Subject: BAR Action - 207 14th Street, NW

BAR # 24-05-01

207 14th Street, NW; TMP 090070100

Project: Mural on east elevation

Approved alterations to 14th Street elevation (2022)

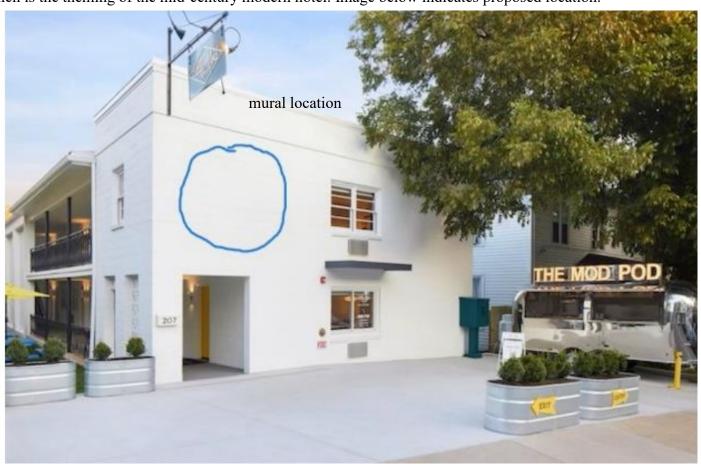
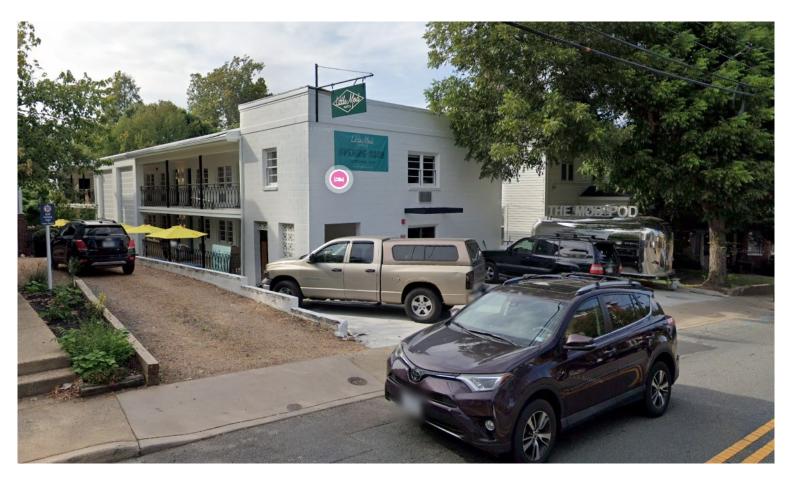
Request CoA for a painted mural (within area of approximately 8-ft x 8-ft) on the east elevation, facing 14th Street.

The building's masonry walls are painted. The proposed mural will not obscure or interfere with architectural element. Staff recommends approval of the CoA with the condition that prior to installation of the mural the applicant review with staff a draft of the artwork to:

- a) confirm it does not constitute a commercial sign (if so, the City's sign regs will prevail); and
- b) the colors and content are appropriate for the district (if staff finds they conflict, the matter will be referred to the BAR for a decision, but that referral will not require a formal resubmittal).

Motion to accept applicant's request for deferral: <u>Schwarz</u>. Second: <u>Bailey</u>. Vote: <u>8-0</u>. Note: In accepting the request for deferral, the BAR also expressed unanimous support for a mural at the proposed location; however, because the actual artwork has not been developed and citing the design guidelines [Chapter 6, Section J, as it relates to murals], the matter was deferred to allow the BAR to formally review the artwork when ready.
